# STAFF REPORT

## REGIONAL CENTER HEARING EXAMINER - HIGH IMPACT CASE

<b>Case Number</b>	2024-REG-032
<b>Address (approx.)</b>	817-831 Charles Street (odd) and 826-840 Union Street (even)
<b>Location</b>	Center Township, Council District #18
<b>Petitioner</b>	Honor Investments LLC, by Russell L. Brown
<b>Zoning</b>	CBD-2 (RC)
<b>Request</b>	Regional Center Approval to provide for the construction of 16 townhomes within four, four-story buildings, with attached garages.

Newell Building - Building 1A2  
**WOVE**  
 ARCHITECTS  
 1000 ...  
 2025  
 2024  
 2023  
 2022  
 2021  
**A201**

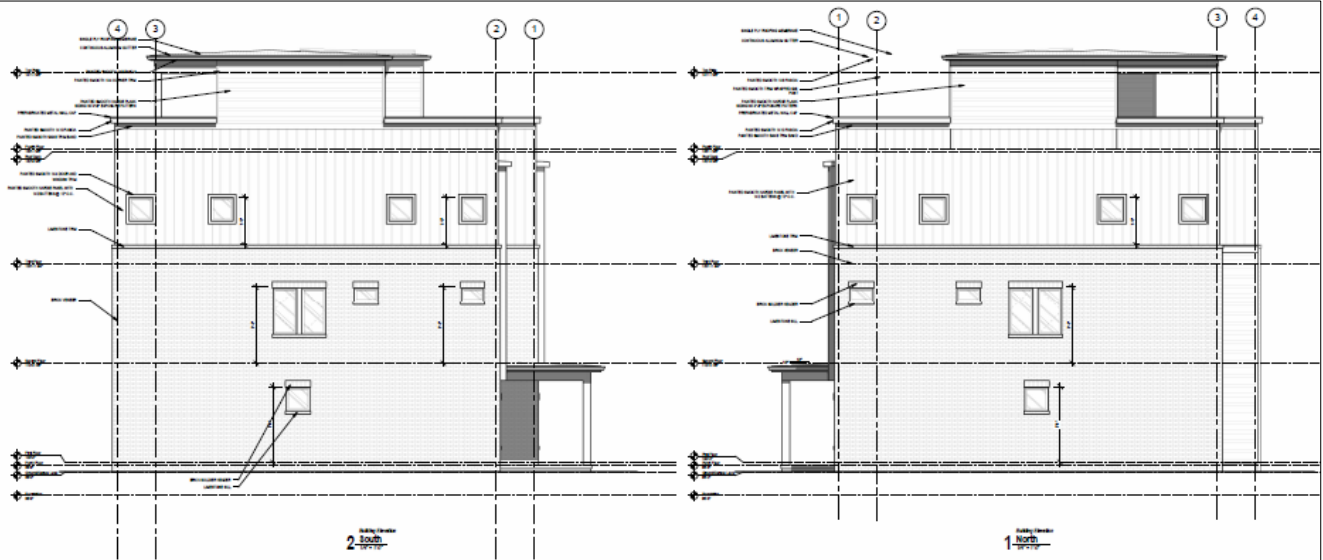
1. The structures would be privately-owned single-family attached dwellings. The location is one block east of Meridian Street and less than one block south of McCarty Street. Mixed-use development is preferred, however, single-family attached dwellings (townhomes) are permitted in CBD-2, as a stand-alone use. Guidelines SC 1.2.1, SC 1.3.1, SC 1.3.2, and SC 2.5.3 require mixed-uses and grade level activation. These Guidelines cannot be met with a townhome development. Since CBD-2 permits this use, this is an acceptable deviation of the Guidelines.

2. A photometric plan has not been submitted to the file. A photometric plan should detail light standards and photometric levels for the site and at each entrance. Lighting must be provided at each entrance and must be dusk to dawn. Only full cut and shielded light standards are permitted with minimum foot-candle power outlined in CA 4.3.2 and CA 4.3.3. Pedestrian areas and entries must be lighted for safety (CA 3.1.3 and CA 4.3.1). The lighting details shall be submitted and subject to planning staff review and approval, prior to the issuance of an Improvement Location Permit.

Staff **recommends approval** of the Regional Center Approval petition, subject to the following conditions:

1. The Summary items must be met.
2. Address numerals shall be installed on the building façade per Guideline CA 2.5.8, prior to building occupancy.
